UNITED STATES
NUCLEAR REGULATORY COMMISSION
WASHINGTON, D.C. 20555-0001

SUBJECT: MEETING SUMMARY - MEETING WITH BWX TECHNOLOGIES
 TO DISCUSS THE DECOMMISSIONING OF THE PARKS
 TOWNSHIP FACILITY

Subject: Parks Facility - Decommissioning Plan

REV. 2
CHANGE SUMMARY

Figure 3-2, Rev. 2
Parks Environmental Restoration
Project Organization

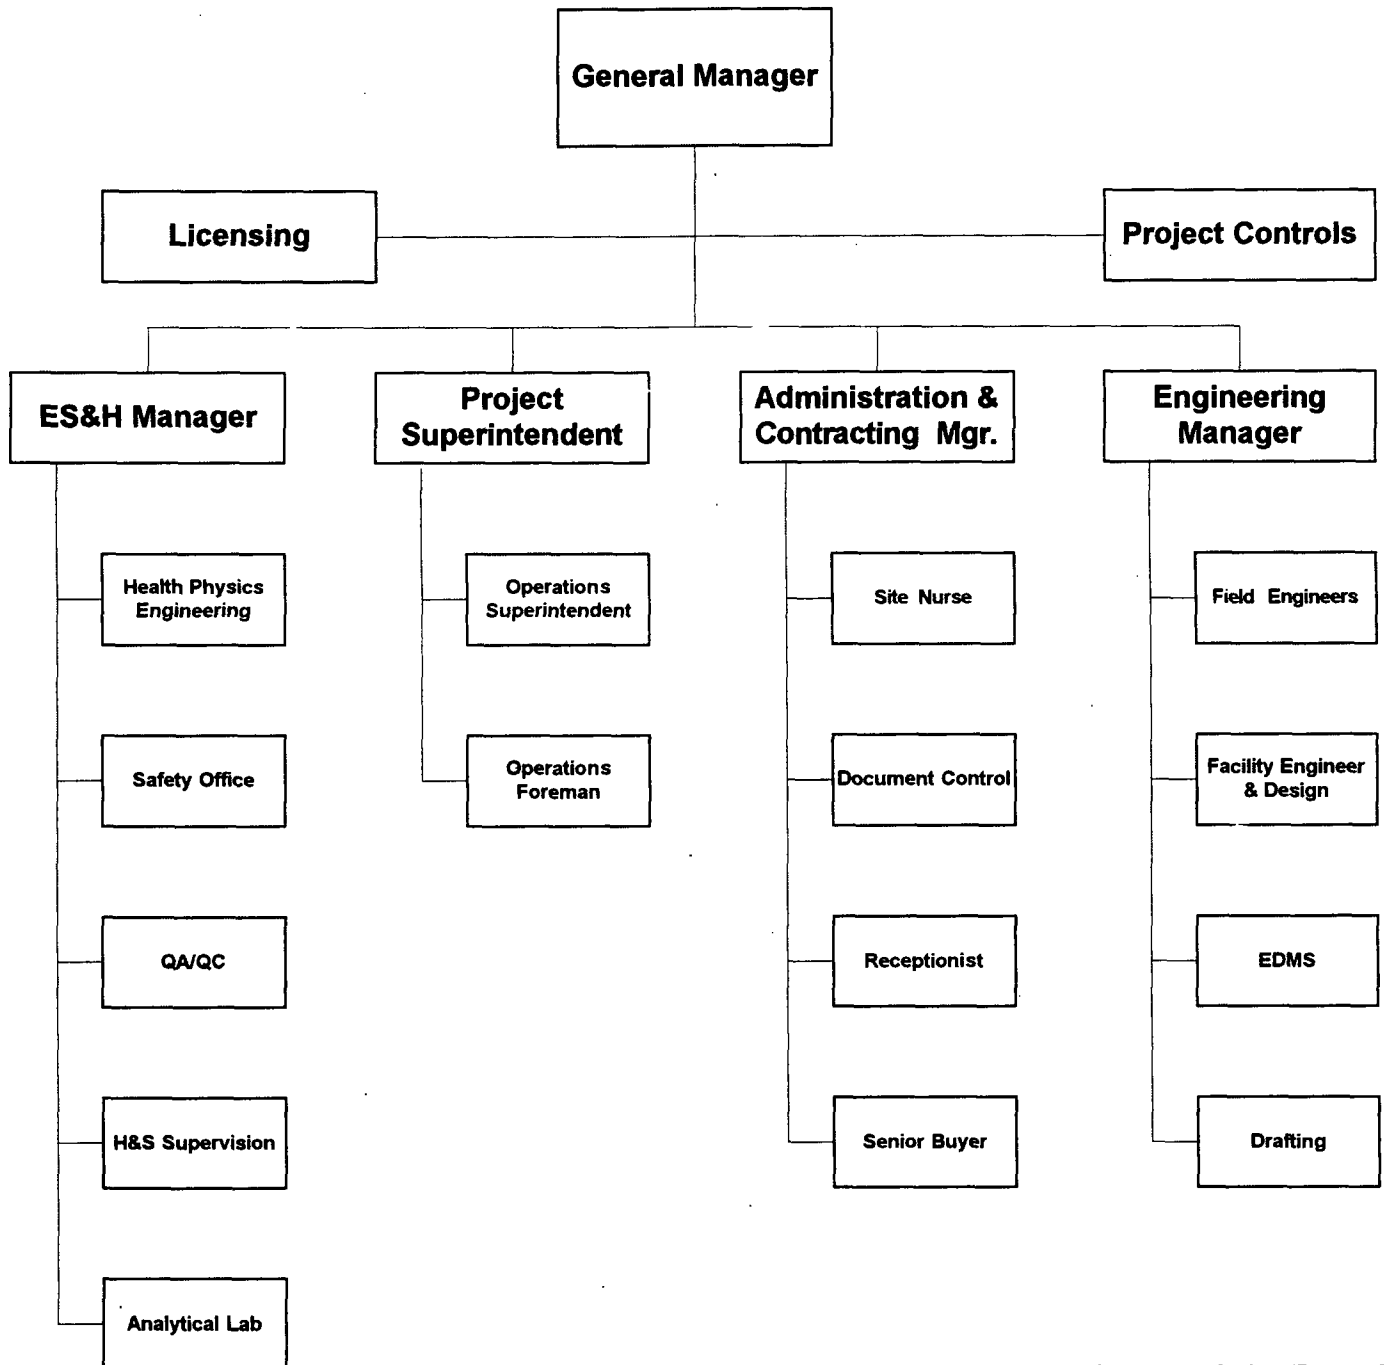
8. Section 3.6 has been revised to reflect the Parks Environmental Restoration Project management structure, duties, and responsibilities.
9. Section 3.8 has been changed to reflect current estimated soil and debris volumes.

- Page 3-15. Section 3.9 has been added to include specifics on the Outfall 2 and 3 Remediation Plans.
- Figure 3-2. Revised to reflect current organization.
